APPLICATION NO.	FILING DATE	FIRST NAMED INVENTOR	ATTORNEY DOCKET NO.	CONFIRMATION NO.
10/709,043	04/08/2004	Christoph Hemming	P7448US	3042
30008	7590	02/06/2006		
GUDRUN E. HUCKETT DRAUDT			EXAMINER	
LONSSTR. 53			CADUGAN, ERICA E	
WUPPERTAL, 42289				
GERMANY			ART UNIT	PAPER NUMBER
			3722

Office Action Summary	Application No.	Applicant(s)
	10/709,043	HEMMING ET AL.
	Examiner	Art Unit
	Erica E. Cadogan	3722

DETAILED ACTION

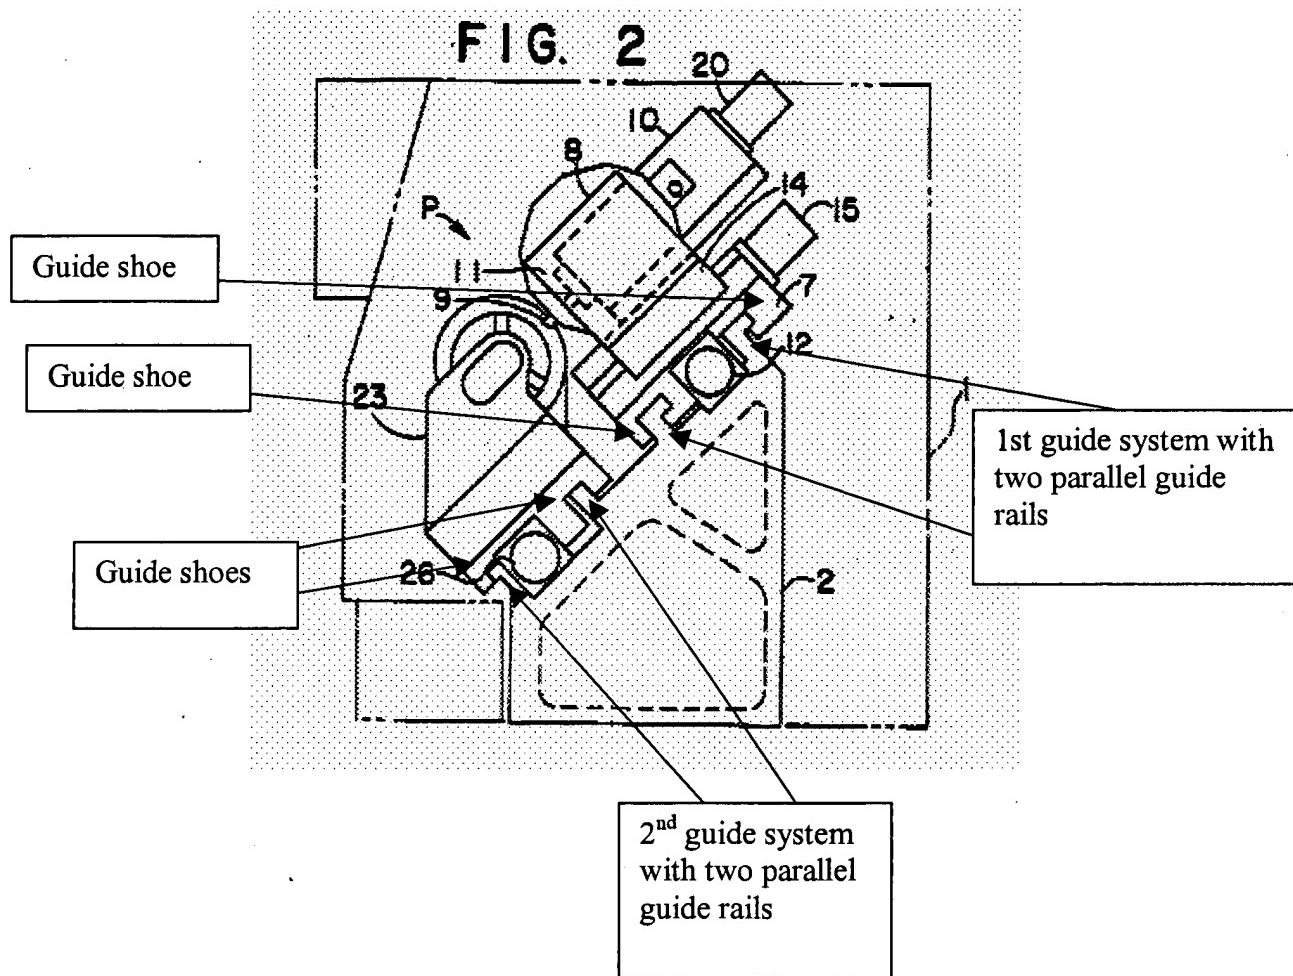
As shown in the above reproduction of Figure 2, Yonemoto teaches two parallel guide systems, each including two parallel guide rails. Carriage 7 (shown above) is a “compound slide” that moves along the guide rails of the 1st guide system (in the “longitudinal” or Z direction as viewed in Figure 3) via motor 12 and ball screw 13 (Figures 2 and 3, for example). Additionally, carriage 7 includes a first cross slide or “slide part” or “milling unit” (in that it carries milling tool 9 as described previously) 14 that moves transversely to the “longitudinal” Z direction in the X direction via motor 15 and screw 16 (see Figures 2-3, for example).

Re claim 9, see the labeled “guide shoes” for the first guide system on the reproduction of Figure 2 above.

Re claims 11 and 13, see the labeled “guide shoes” for the second guide system on the reproduction of Figure 2 above, again noting that (re claim 11) stock 23, as broadly claimed, can be considered the claimed “head stock”, or that stock 23 can alternatively (re claim 13), as broadly claimed, be considered the claimed “steady rest” in that it holds the workpiece “steady”.

Re claims 35-36, see Figure 2, for example, noting that the side of the bed on which the aforedescribed 1st and 2nd guide systems are located is "inclined" with respect to at least the horizontal direction as viewed in Figure 2.

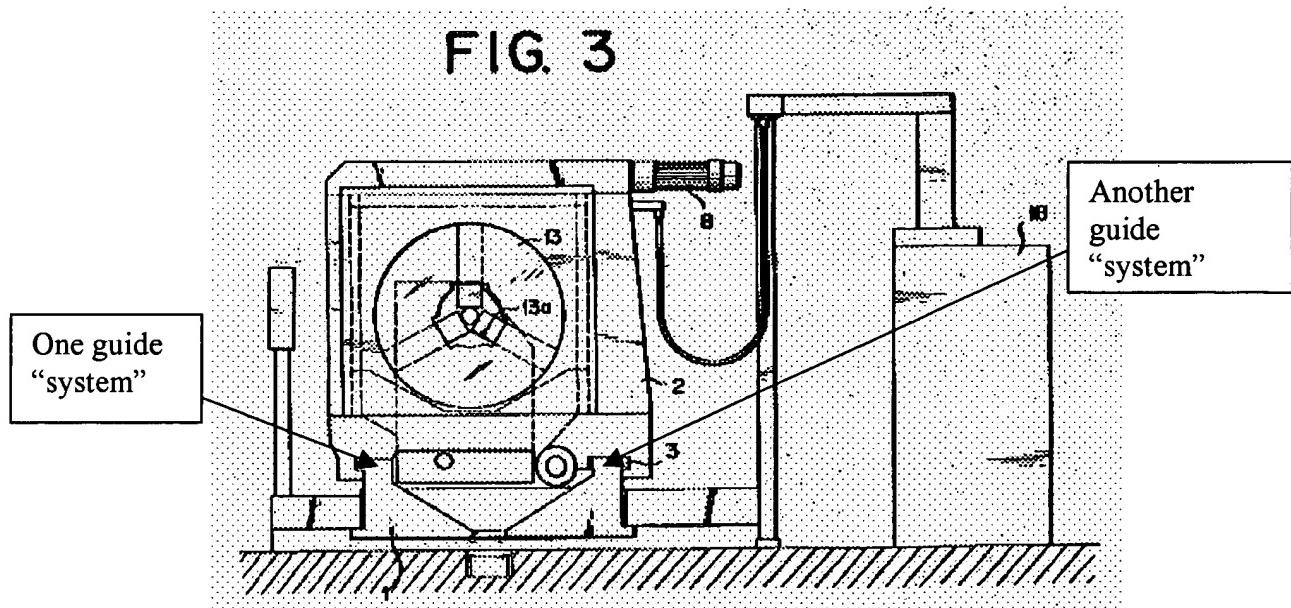
Yamade et al. teaches a machining tool including internal milling cutters 10 (see Figures 2 and 5). "Compound slides" 2 (Figures 2 and 4) move along the parallel first and second "guide systems" of interconnected "guide shoes" and "rails" labeled below in the reproduction of Figure 3 (note that these guide systems are in the left/right horizontal direction as viewed in Fig. 2).
